Re: Test Procedure for Commercial Refrigeration Equipment [Docket No. EERE-2013-BT-TP-0025/RIN 1904-AC99]

These comments are submitted by the Air-Conditioning, Heating, and Refrigeration Institute (AHRI) in response to the U.S. Department of Energy's (DOE) notice of proposed rulemaking (NOPR) appearing in the Federal Register on October 28, 2013. The document pertains to the test procedure for commercial refrigeration equipment (CRE).

Exhibit 1 – Methodology for Measuring Total Display Area - Docket Number EERE-2013-BT-TP-0025

Figure D12 from AHRI 1200-2013 and a front view of VCT.XX.X equipment illustrating the two different methods of measuring TDA:

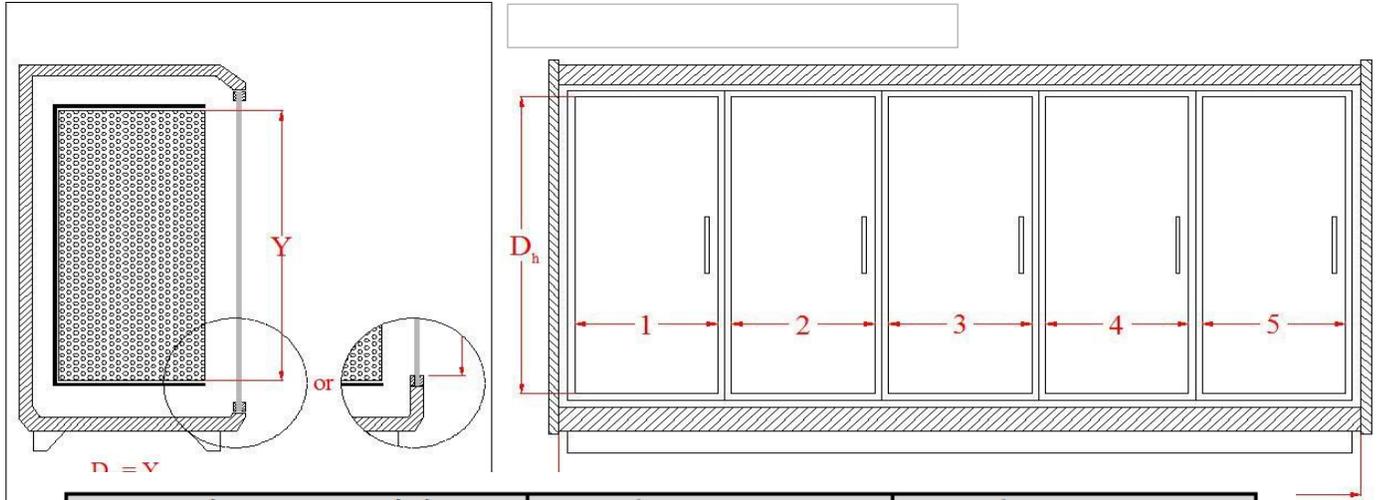
We believe that the test procedure should be simple enough to calculate the length. Additionally, unlike solid features such as deck pans and honeycombs, consumers do not generally view door mullions and door frames as being permanent impediments to the projected visible area; these materials do not have an adverse impact on the visibility of a product within the refrigerated space. DOE is introducing an added level of complexity to the test procedure by proposing the exclusion of the widths associated with door mullions and door frames. Exhibit 1 illustrates that:

- DOE used the method outlined in Interpretation 2 of AHRI Standard 1200-2010 to calculate length and TDA in the 2008 and 2013 engineering analyses; these values were used to create the current VCT.XX.X equipment standard levels and proposed levels respectively.
- The effect of changing the method of how TDA is measured within the current test procedure NOPR is significant deviation from the historical practice that DOE has followed in its engineering analyses for the CRE energy conservation standards. The change clearly alters the TDA-normalized measured efficiency (kWh/day/ft²) for several CRE products. Hence, we do not agree with DOE's following assertion on page 64299 of the test procedure NOPR:

1. DOE should account for door mullion and door frame widths up to 5 inches within the TDA calculation. We believe that widths up to 5 inches would not impede the projected visible area for consumers in any manner. For non-visible areas that have widths greater than 5 inches, the length calculation should only include 5 inches of that non-visible portion, so that the TDA calculation can account for the consumer's vantage point based on the consumer being positioned on one side of the case. As an example, in the case of scenario 3 (slide 70 of DOE's public meeting presentation), assuming that length B-(C+D) totals 15 inches, at least 5 inches of that length should be factored into the TDA calculation.

DOE's Engineering Analysis	Manufacturer A - VCT.RC.L	Manufacturer B - VCT.RC.L
From Engineering analysis spreadsheet	From published data	From published data
30" x 67" Doors	30" x 67" Doors	30" x 67" Doors
$D_h = 5.10$ ft	$D_h = 5.26$ ft	$D_h = 5.21$ ft
$L = 12.74$ ft	$L_{AHRI} = 12.5$ ft	$L_{AHRI} = 12.78$ ft
Case TDA = 65.00 ft²	Case TDA_{AHRI} = 65.76 ft²	Case TDA_{AHRI} = 66.55 ft²
Standard level = 39.01 kWh/day	Standard level = 39.44 kWh/day	Standard level = 39.88 kWh/day
	$L_{DOE} = 10.83$ ft	$L_{DOE} = 11.41$ ft
	Case TDA_{DOE} = 56.98 ft²	Case TDA_{DOE} = 59.44 ft²
	Standard level = 34.52 kWh/day	Standard level = 35.90 kWh/day
	A reduction of 12.5%	A reduction of 10.0%

The above spreadsheet clearly indicates that DOE used the AHRI method of calculating TDA in the DOE engineering analyses for determining the CRE standard levels for 2012 and the proposed standard levels for 2017. Changing the method of calculating TDA drastically reduces the standard level by 10.0 to 12.5 percent for VCT.RC.L equipment.
